Meeting Agenda Plat Committee

Monday, September 26, 2022

1. [KPB-4602](#) Corea Bend Subdivision 2022 Addition; KPB File 2022-131

2. [KPB-4603](#) Trout View Subdivision; KPB 2022-127

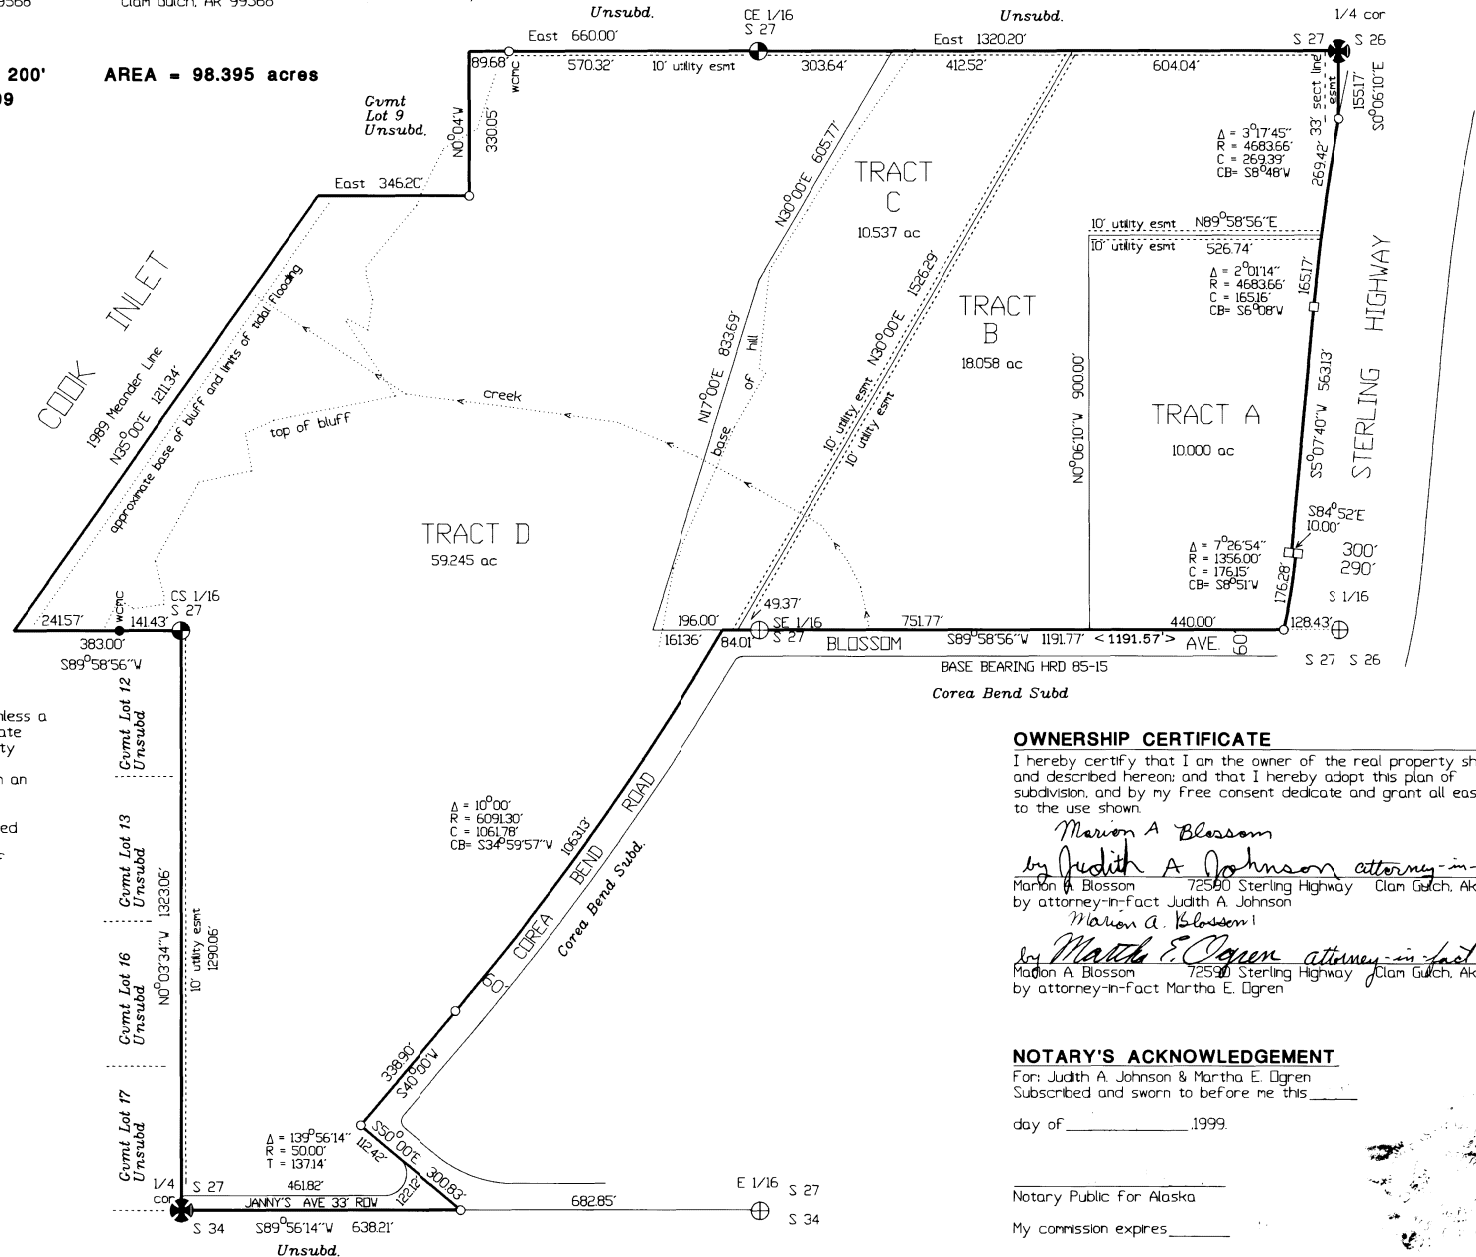
Staff recommendation: *In the located portion remove "Gov Lot 10 and the".*
- C. The location, width, and name of existing or platted streets and public ways, railroad rights-of-way, and other important features such as section lines or political subdivisions or municipal corporation boundaries abutting the subdivision;

Staff recommendation: *Remove the line and arrow with "Ninilchik 9 miles" label. Not required but if wanting to give a better idea of location could add milepost of the Sterling Highway.*
- F. The location, width and name of existing and platted streets and public ways, railroad rights-of-way, easements, and travel ways existing and proposed, within the subdivision;

Staff recommendation: *Labels that indicate the dedications occurring should be added as wells as street name labels*
- G. The status of adjacent lands within 100 feet of the proposed subdivision boundary or the land status across from any dedicated rights-of-way that adjoin the propose subdivision boundary, including names of subdivisions, lot lines, block numbers, lot numbers, rights-of-way; or an indication that the adjacent land is not subdivided;

Staff recommendation: *Lands within 100 feet not labeled correctly to the northeast. Block numbers need to be added to the lands to the southwest. Government Lot 9 can have the unsubdivided label removed as Government Lot 9 is the designation. To the north of the subdivision replace the unsubdivided label with Government Lot 7. For abutting southern lots on both sides of the subdivision, adjust the subdivision name labels to indicate that lots on both sides of their rights-of-way are part of the same subdivision or add a second label for each.*

Staff recommendation: comply with 20.60.110. Show measured and recorded dimensions. Some data missing. Provide a line and curve table to clean up the drawing. Provide source of meander line.

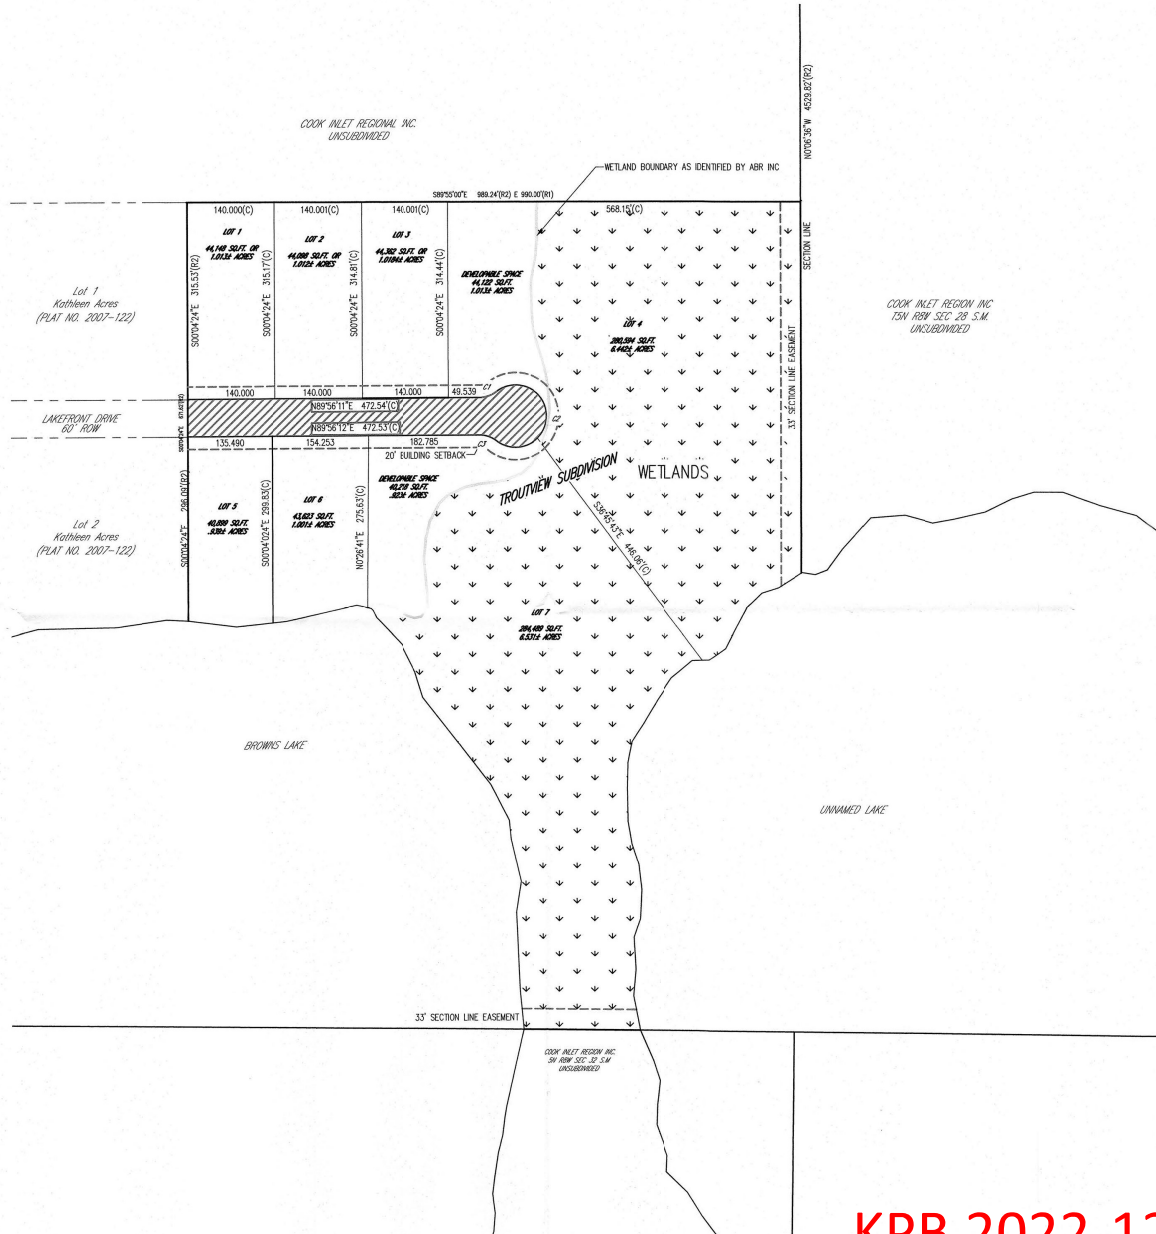
The legend will need to be reviewed to make sure the correct labels are present for what is being depicted. Make the legend stand out more.

The final plat will only be required to contain the acreage for each lot. The square footage labels may be removed. The two lots with wetlands should have their overall acreage listed and the upland acreage listed instead of listing it as developable space.

- *The owner's information is required within the title block, this includes their mailing address.*
- *Update the spelling of "Kenai" in the recording district information.*
- *Provide within the title block or near it the KPB File number of 2022-127.*
- *Provide an aliquot location with the located within information, "SE1/4 SE1/4".*

Staff recommendation: *Verify the section line easements within and abutting the subdivision. KPB data indicates that they may be subject to 50 foot wide easements. Provide documentation to show if not 50 feet. Label all section lines as such if they are depicted even if outside the bounds of the subdivision and adjust the line style as the ones to the south appear to be proposed parcel boundary.*

Staff recommendation: *Shade the plat in fully so that it stands out better. Provide a few labels for the major roads in the area such as Browns Lake Road and Lake Road.*

Staff recommendation: *Ownership is not recommended for the final as ownership changes. On the final remove reference to CIRI. The lots north of the unnamed lake and east of the subdivision should be labeled as Government Lot 9 and Government Lot 8 north of it. The lot south of proposed Lot 7 should be labeled as Government Lot 1.*

Staff recommendation: *Stated was included but did not see with submittal. Some areas may be near the 20 percent grade in the northwest corner. Top and toe of bank need to be shown on the drawing.*

Staff recommendation: Verify that fonts are compliant and adjust a few to make sure all are clearly legible and no overstrikes. Comply with 20.60.070.
